Tillbridge Solar Farm

Local Impact Report – November 2024

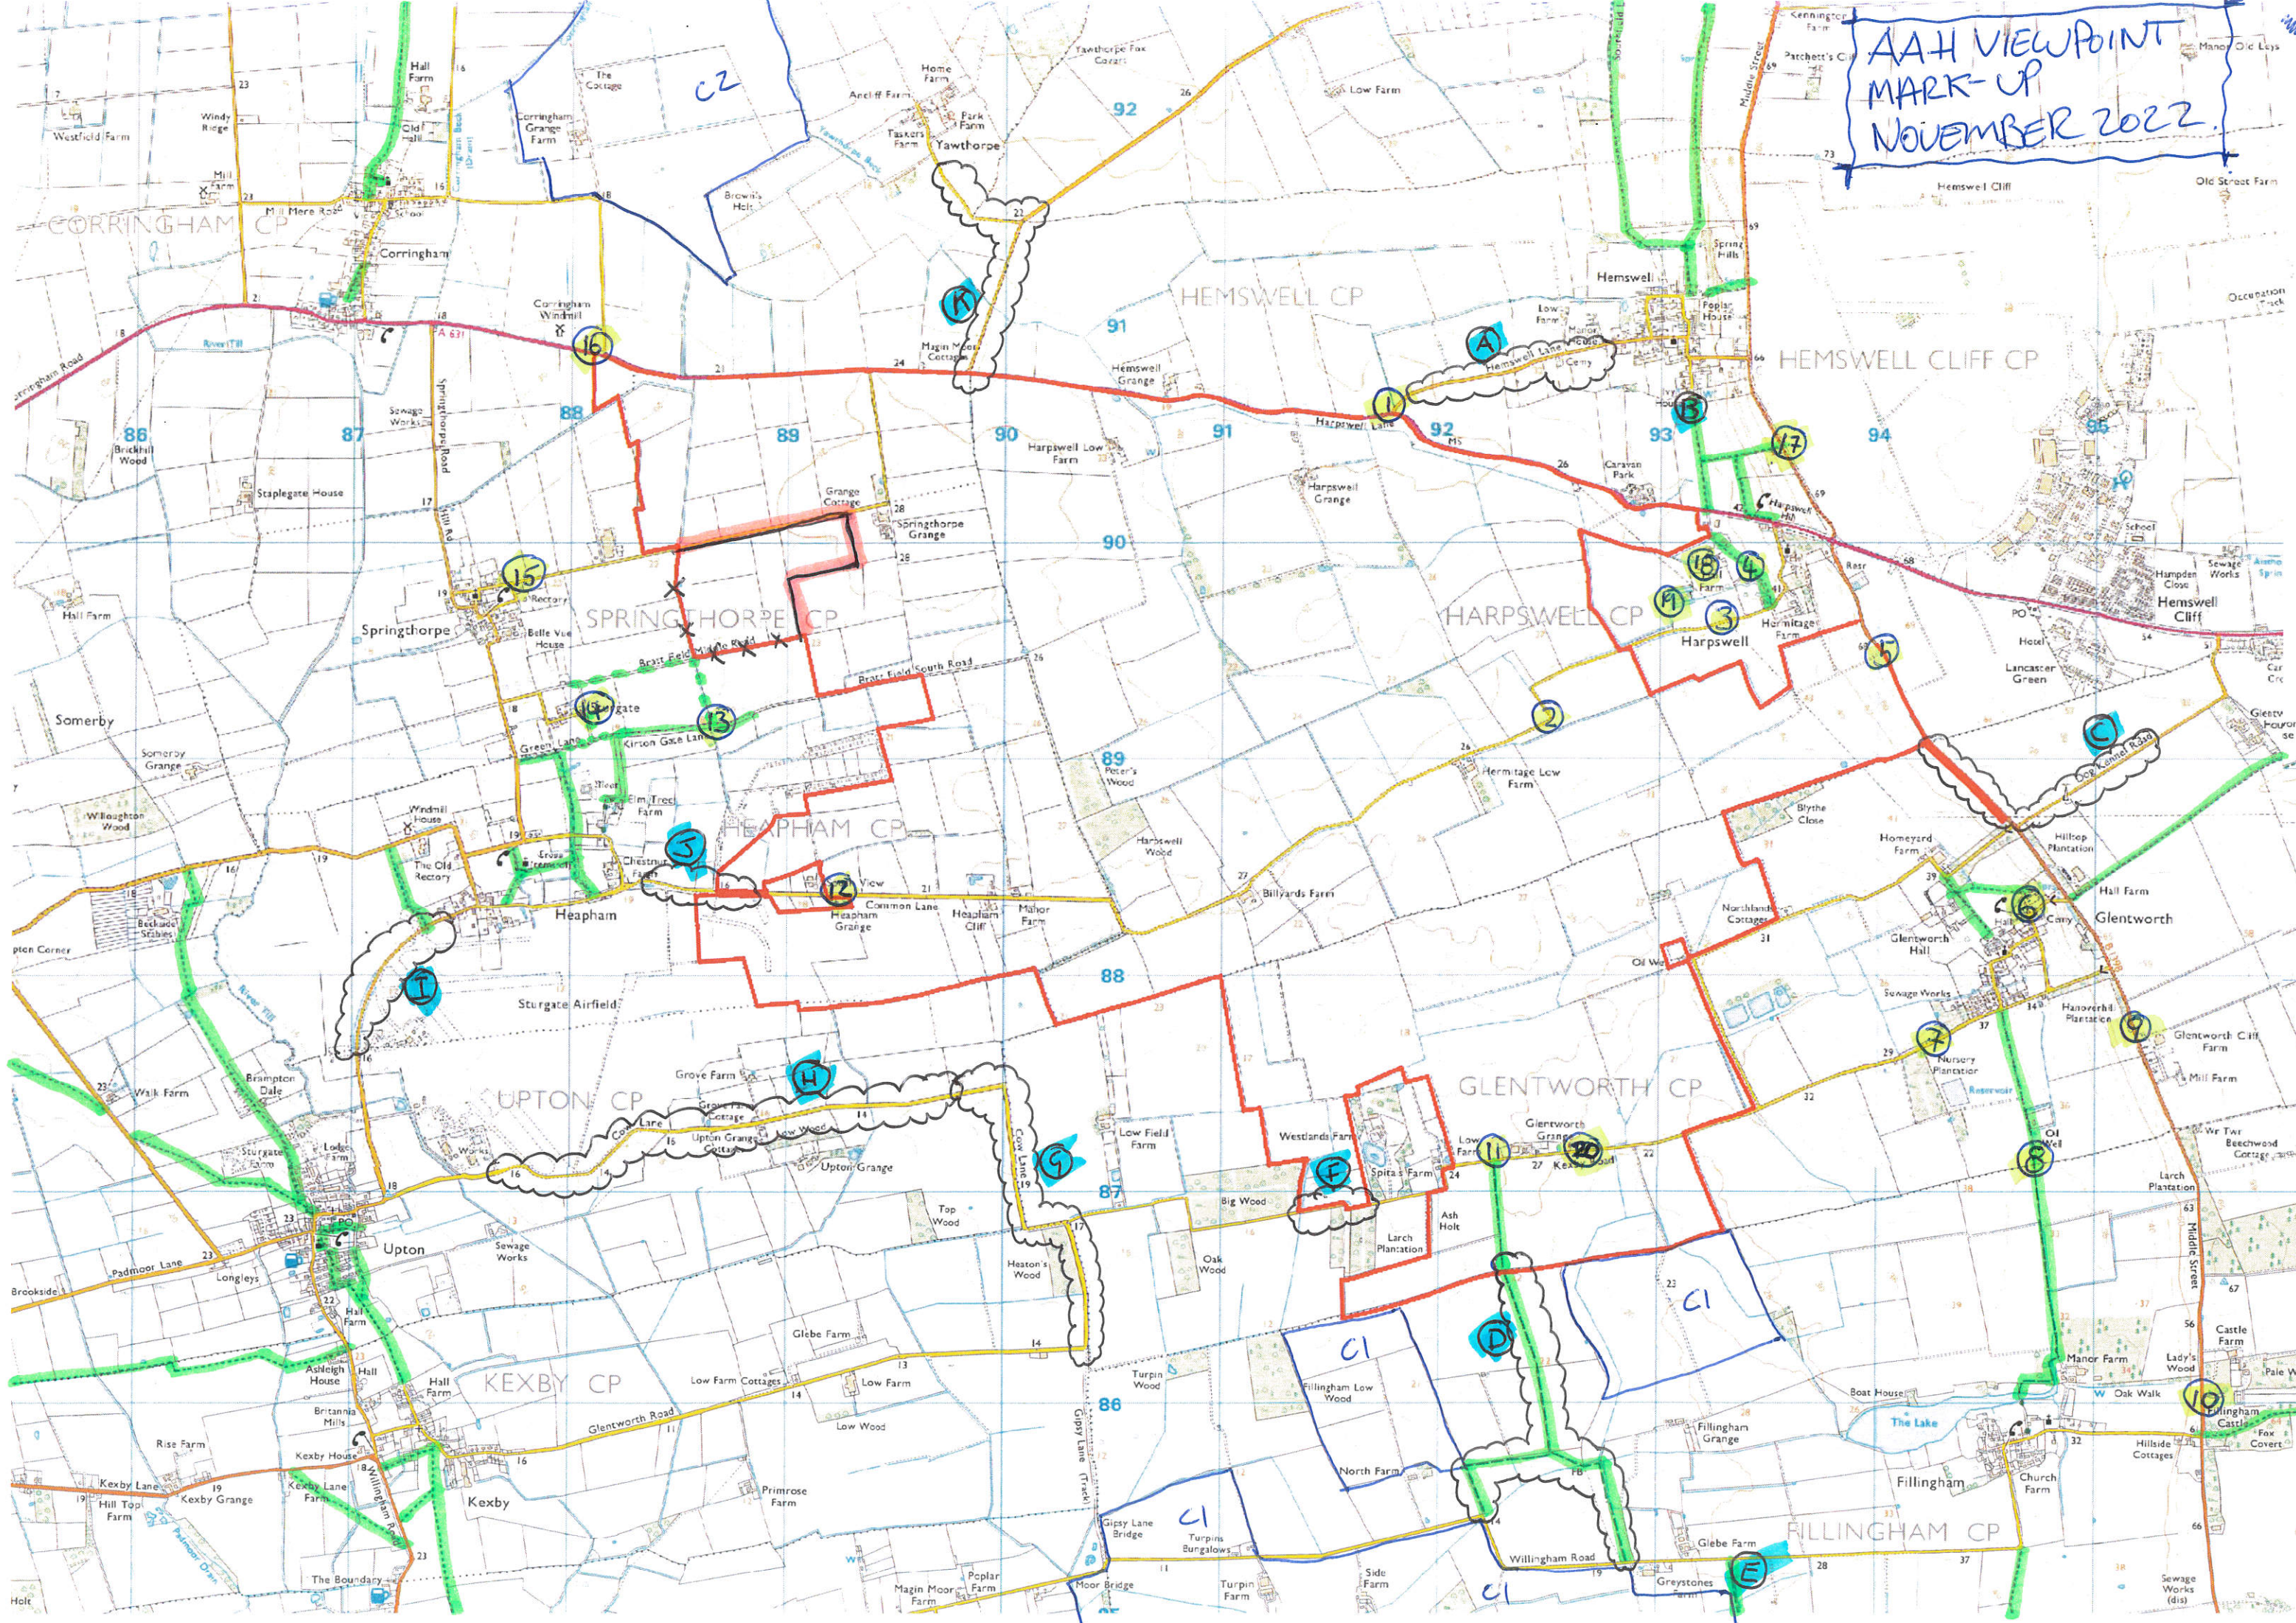
- J. **Potential additional viewpoint included from along Common Lane east of Heapham.** Unclear as to whether views of the development would be available from this location as the adjacent areas of the site are currently shown as mitigation (no panels or other development), however would demonstrate potential visibility from settlement edge; and

- K. **Potential additional viewpoint included from along Yawthorpe/Willoughton Road.**

As stated, at this stage we do not have details on the location and appearance/extent of taller/larger elements that for part of the development which would likely have visual impacts that may require additional viewpoints beyond those initially identified.
